MFN 06-191
Supplement 10

Subject: Response to Portion of NRC RAI Letter No. 228 Related to ESBWR Design Certification Application – DCD Tier 2 Section 3.8 – Seismic Category I Structures; RAI Number 3.8-41 S06

**Response to Portion of NRC RAI Letter No. 228
Related to ESBWR Design Certification Application**

RAI Number 3.8-41 S06

Figure 3.8-41(26). Floor Response Spectrum—AP Envelope, Node: 701 Vertical

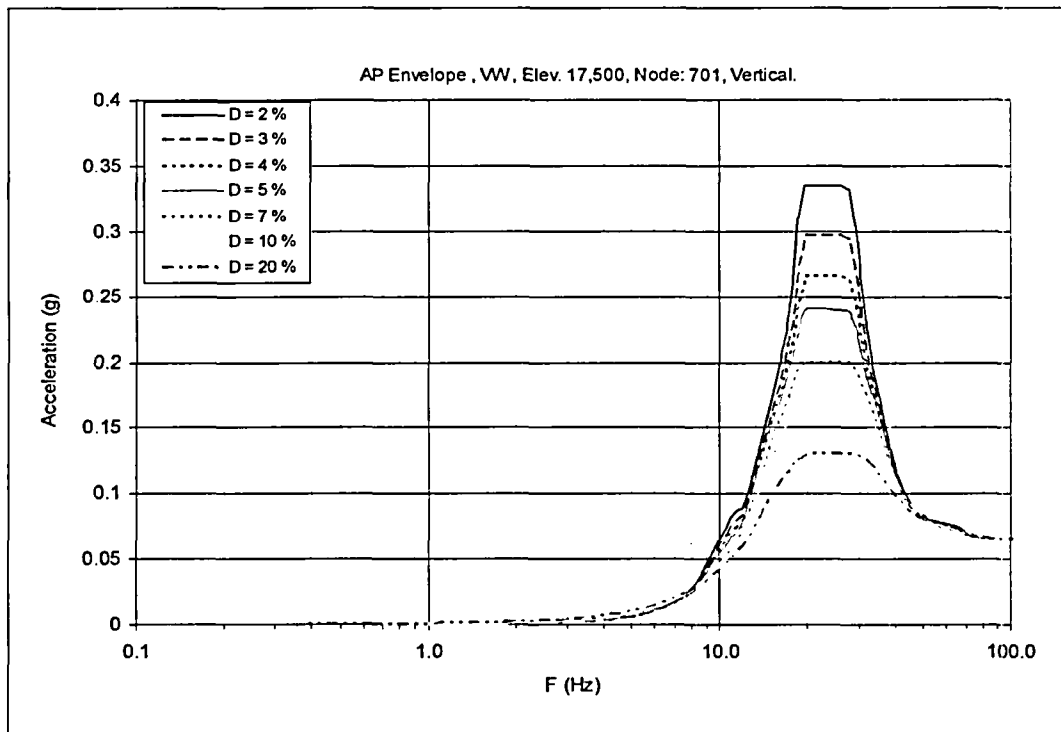
The results presented raise a concern whether 50% of the uncracked concrete stiffness is the appropriate assumption. If 75% or 100% of the uncracked concrete stiffness had been used, then the frequency increase would be greater. GE needs to provide its technical basis for the 50% assumption, for the confined unreinforced in-fill concrete. The response only discussed seismic loading; GE needs to provide an assessment of the effect of the in-fill concrete on response spectra generated from hydrodynamic loads (SRV & LOCA). GE also needs to confirm that all thermal loading conditions analyzed using NASTRAN (including normal operating conditions) have been adjusted to account for the presence of the concrete infill, using thermal ratios obtained from ABAQUS/ANACAP thermal stress analyses.

The effect of in-fill concrete stiffness on hydrodynamic response has been evaluated for the same two conditions, no concrete stiffness and 50% concrete stiffness, as considered in the seismic analysis. The results indicate that the response spectra are mostly affected at the vent wall and diaphragm floor locations. The representative response spectra from the reanalysis are shown in Figure 3.8-41(26) through 3.8-41(31) for various hydrodynamic loads.

Figure 3.8-41(33) Analysis Model for Diaphragm Floor

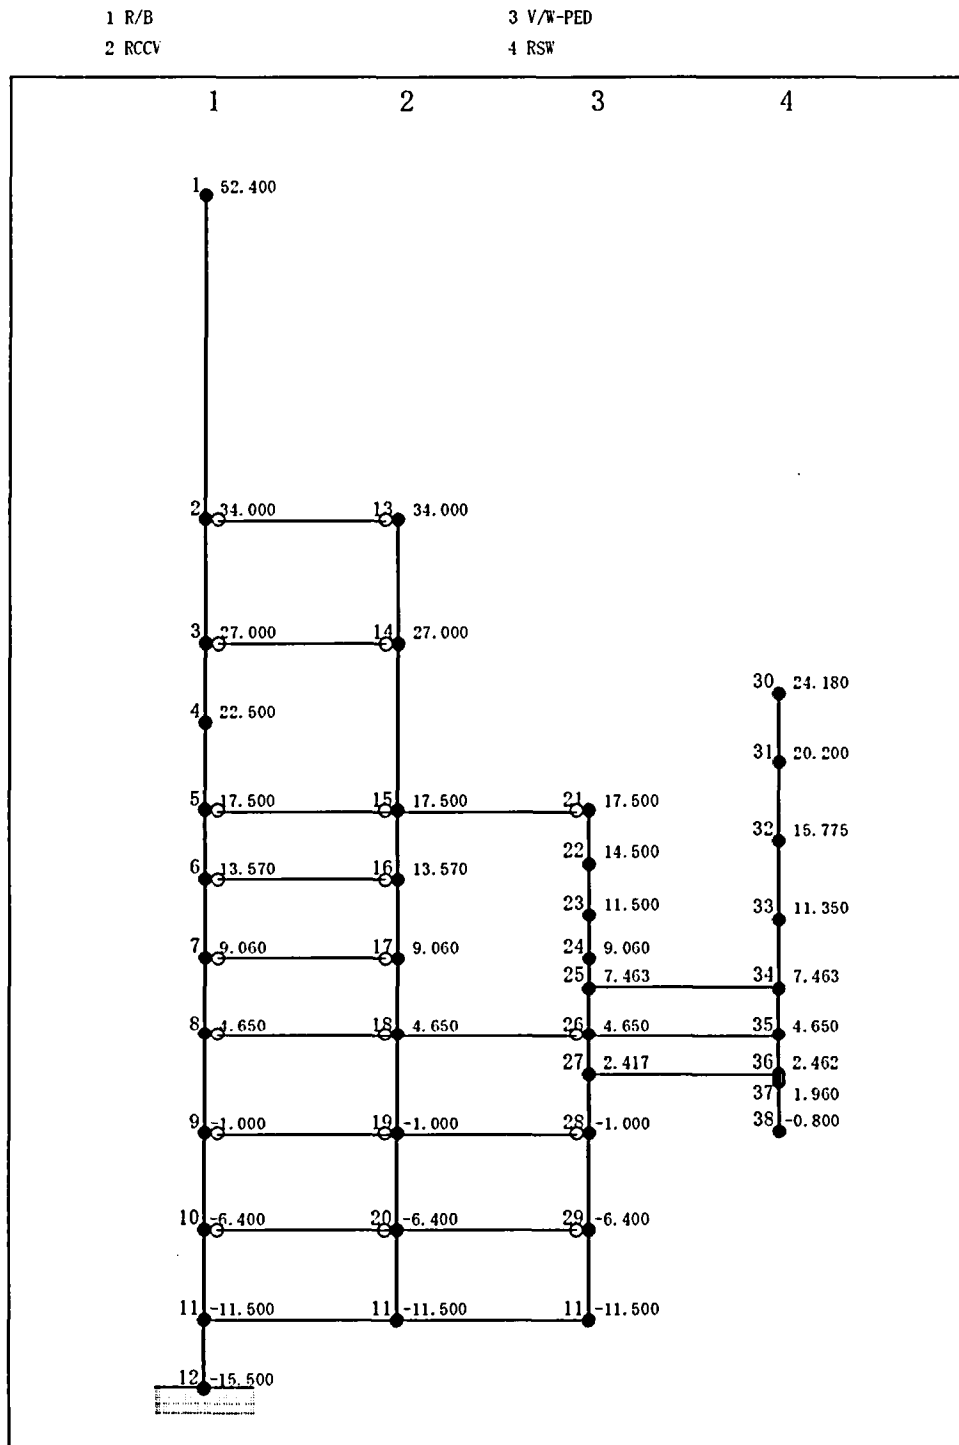
(1) When 50% of the concrete stiffness was considered, the natural frequencies of the vent wall and the diaphragm wall increased 84% and 26%, respectively, compared to the original values. When 100% of the concrete stiffness was considered, the natural frequencies only increased an additional 8 to 10%. Based on the results obtained from considering 50% of the concrete stiffness, GE needs to explain how the natural frequencies could rise only 8 to 10% when 100% of the concrete stiffness values were utilized. For seismic loadings, GE indicated that differences were noted in the floor response spectra at certain locations when 50% of the concrete stiffness values were included. Therefore, GE stated that the results of the infill concrete stiffness parametric evaluation will be included in the site-envelope seismic design loads. In addition, GE indicated that additional parametric seismic analysis is being performed to address containment Loss of Coolant Accident flooding and the effect of updated modeling properties of the containment internal structures. From a review of DCD Rev. 3, it is not clear whether the enveloping and updates of the modeling properties discussed above have been incorporated for the seismic loading.

Natural frequencies of the diaphragm floor were calculated by a 3D FEM model shown in Figure 3.8-41(33).

The effect of concrete stiffness on natural frequencies is further examined by comparing the overall stiffness summarized in Table 3.8-41(3). As shown in this table, the increment of diaphragm floor stiffness ratio from 0 to 50% concrete stiffness is larger than that from 50% to 100% concrete stiffness. This is because the diaphragm floor has girders under the bottom plate, which also contributes to overall stiffness. The neutral axis of the section is below the bottom plate if concrete stiffness is ignored. When concrete stiffness is added between the top and bottom plates, the neutral axis of the section moves upward. As the concrete stiffness becomes larger, the neutral axis moves up further. Because of the neutral axis shift, the total stiffness of the section with 100% concrete stiffness is only 15% higher than that with 50% concrete stiffness. Since natural frequency is proportional to the square root of stiffness, the frequency ratio is only 1.07 when the concrete stiffness is increased from 50% to 100%.

Figure 3.8-41(34) Floor Response Spectrum - AP Envelope, Node: 701, Vertical

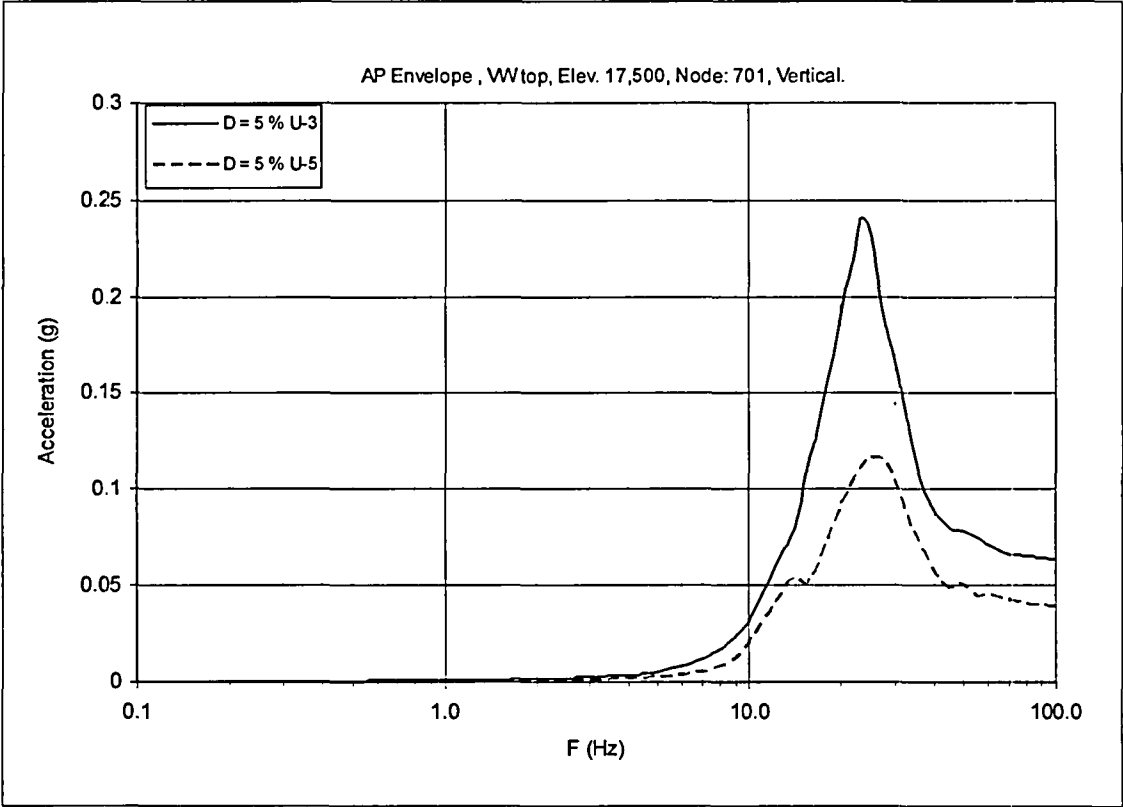
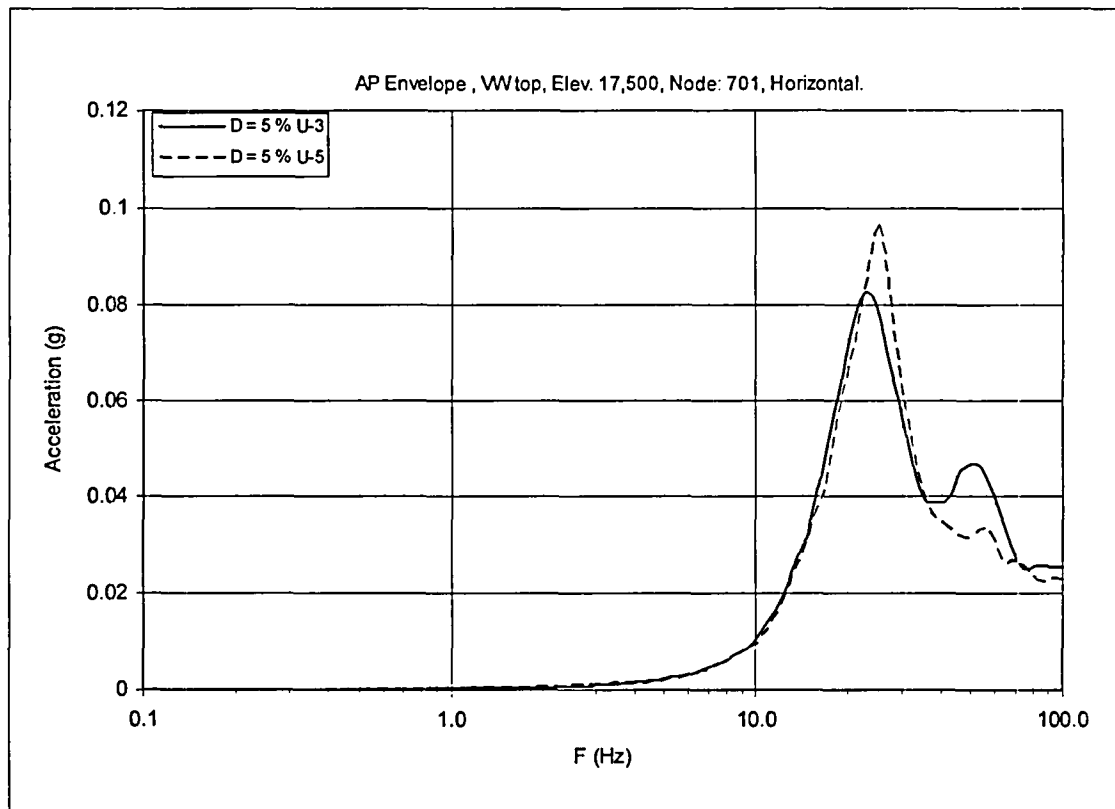
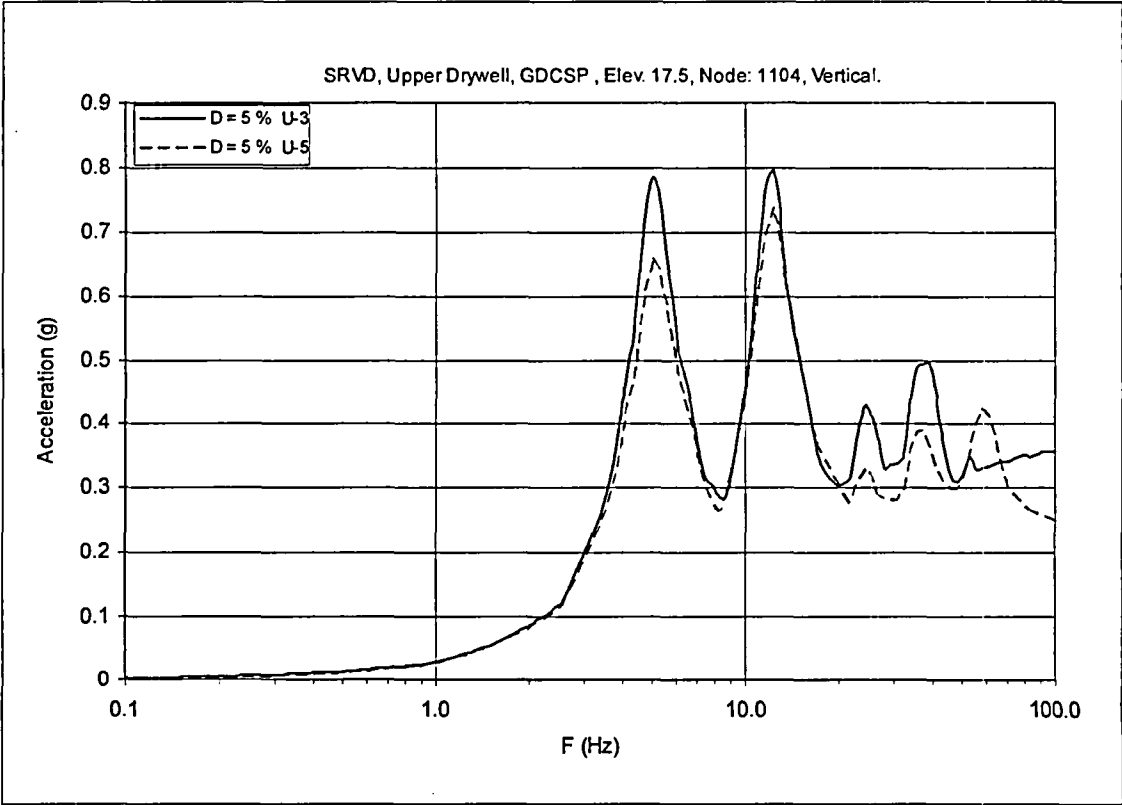
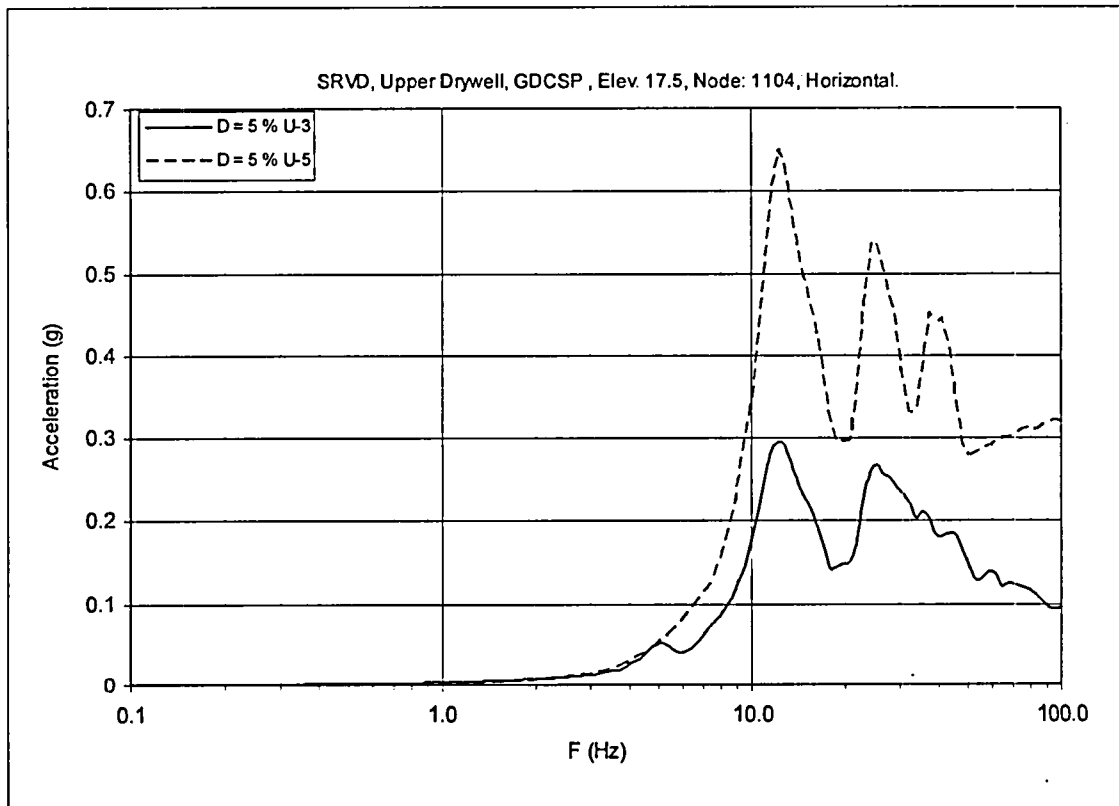
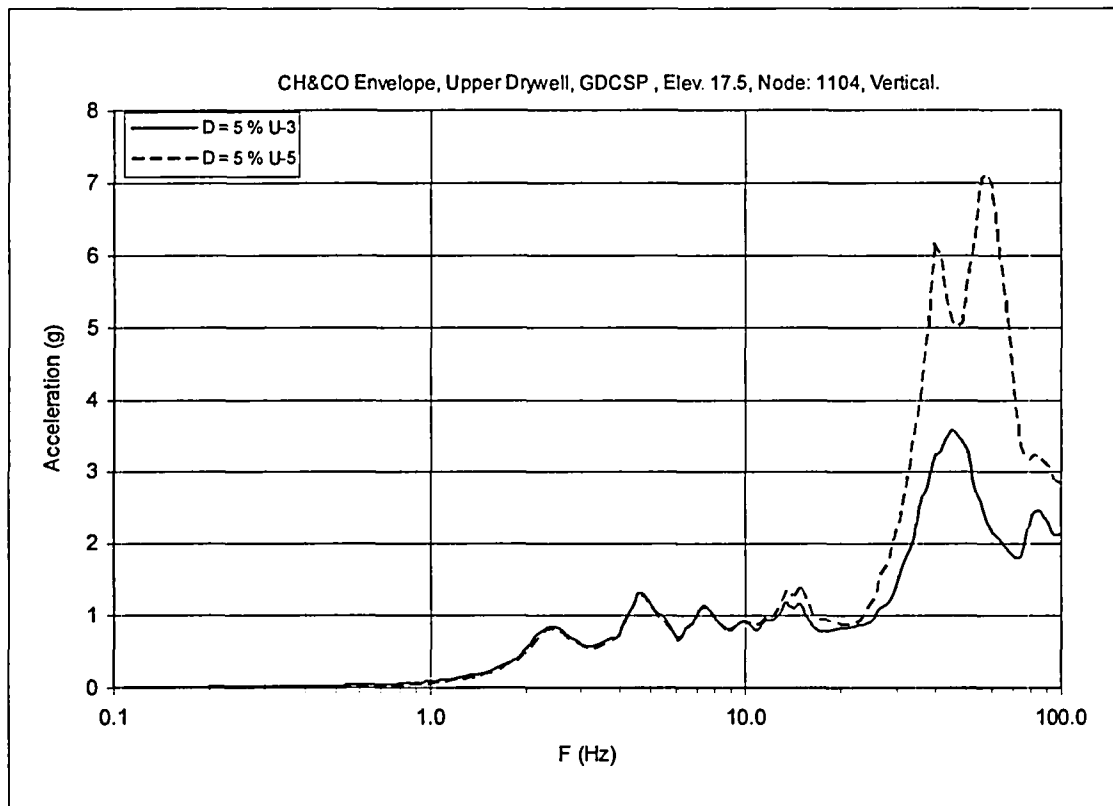
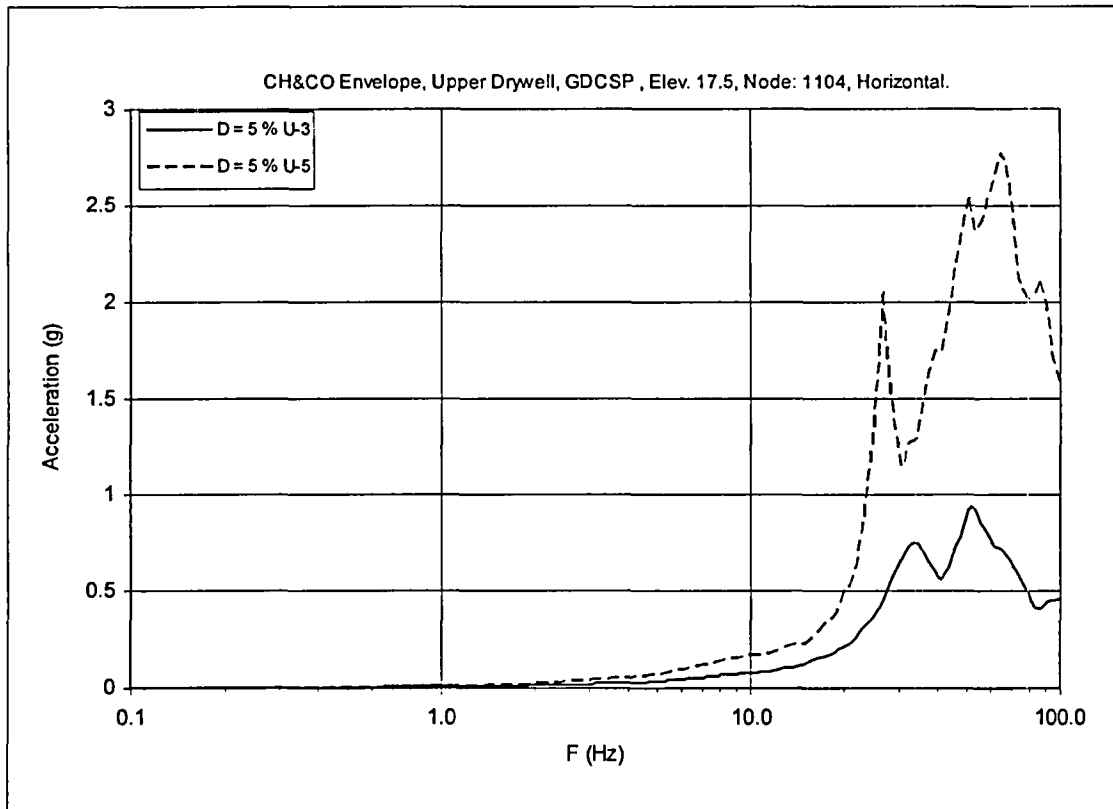
(2) For evaluating the effects of the infill concrete on hydrodynamic response spectra generation, spectra were provided at representative locations for annulus pressurization, safety relief valve, chugging, and condensation oscillation loadings. However, there was no comparison to show how the spectra for the 50% infill concrete case differ from the original (no infill concrete) case, as was done for the seismic case.

- (2) The hydrodynamic floor response spectra between the 50% infill concrete case (labeled U-5) and the no infill concrete case (labeled U-3) are compared in Figures 3.8-41(34) through 3.8-41(39) at the same locations as those in Figures 3.8-41(26) through 3.8-41(31) contained in NRC RAI 3.8-41, Supplement 3. The load cases considered are the Safety Relief Valve Discharge (SRVD) envelope, Chugging (CH) and Condensation (CO) envelope and Annulus Pressurization (AP) envelope.

Figure 3.8-41(59) Comparison of the FE Model

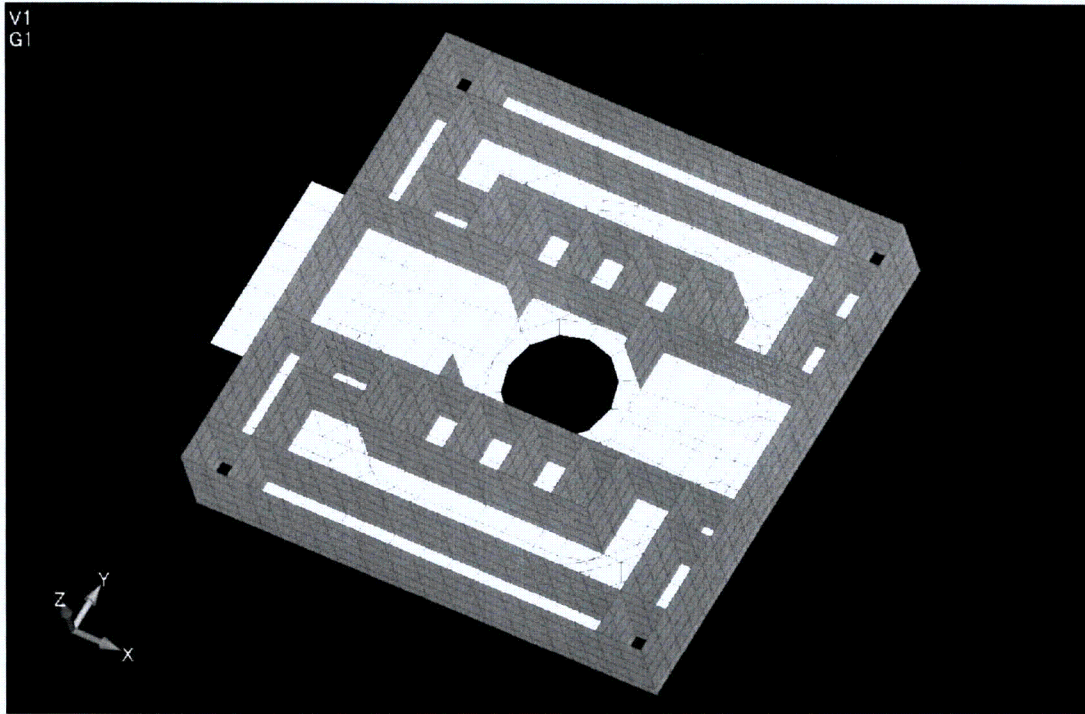
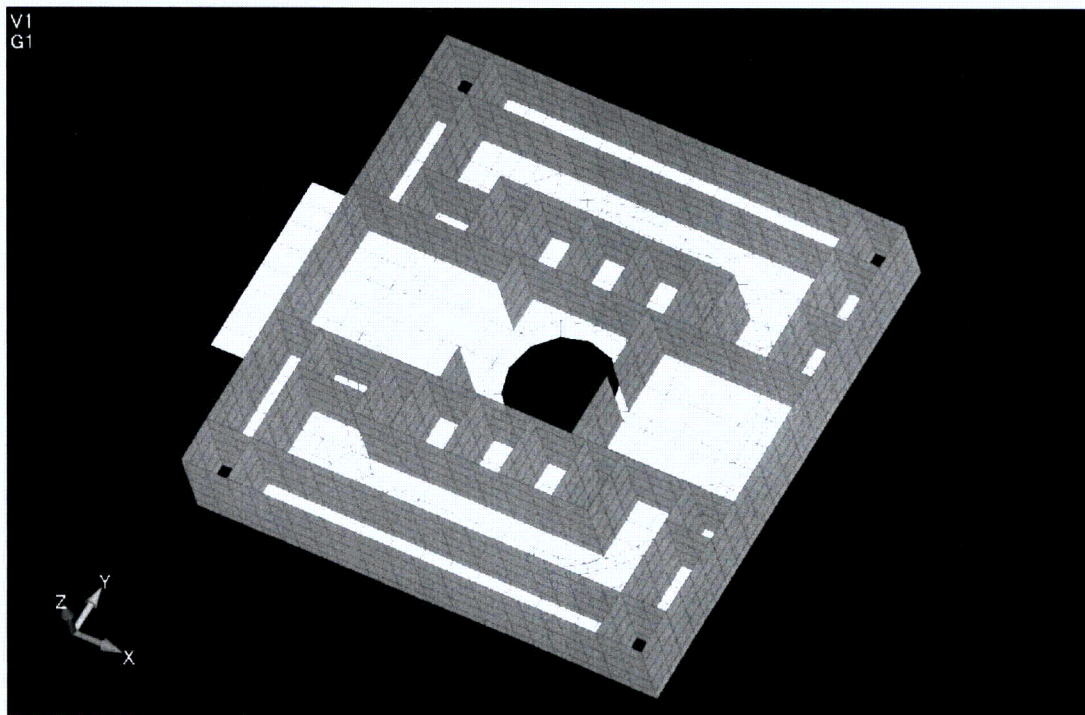
- (a) GEH indicated during the audit that the changes that will be considered in the final design calculation are: (1) consideration of the 100 percent infill concrete, (2) consideration of the revised containment thermal DBA time history (identified in RAI 6.2-180 S01), and (3) widening of the buffer pool gate. GEH also indicated that revisions to DCD Appendix 3G resulting from these changes will not be submitted for review as part of the design certification, but will be performed as part of the detailed design phase. The Design Summary Report and supporting calculations will be prepared to reflect these changes. The staff notes that the introductory paragraph in Appendix 3G of DCD Rev. 5 states that "The final design details, and hence final component stresses may be different from those reported here but they will meet the structural acceptance criteria presented in Section 3.8 in accordance with Tier 1 ITAACs in Tables 2.16.5-2, 2.16.6-2, and 2.16.7-2." Since the three changes listed above may affect the design results, and GEH does not plan to incorporate the changes in the DCD, GEH is requested to (1) identify in the DCD the reported results that did not consider the three changes listed above, (2) perform a quantitative evaluation to demonstrate that structural design will not be affected due to these changes, and (3) include a note in the DCD to state that a quantitative evaluation was performed to conclude that final design will not be affected by the changes.*

To evaluate the potential impact of the widening of the buffer pool gate on the design, the following analysis is performed using the updated global finite element (FE) model shown in Figure 3.8-41(59) in which elements associated with the buffer pool gate and adjacent elements in the RCCV top slab have been modified and compared to the DCD Revision 5 FE model. The accident pressure and accident temperature are the most critical loads in these regions and the following loads are analyzed to compare the element force distributions on the RCCV top slab, pool girder and walls:

As for the thermal load, the element force distributions of all components are almost the same for both models. As for the pressure load, however, the element forces of the 'My' bending moment component around the drywell head opening increase about 20 percent from the DCD Revision 5 element forces as shown in Figure 3.8-41(64). The existing stress margins, which are the ratio of the calculated stress to the allowable stress, in accordance with DCD Tier 2 Tables 3G.1-10 and 3G.1-11 are not sufficient to accommodate the increased accident pressure stress. Therefore, additional bars (1-#14@600) will be added locally and DCD Tier 2 Figure 3G.1-44 will be revised accordingly.
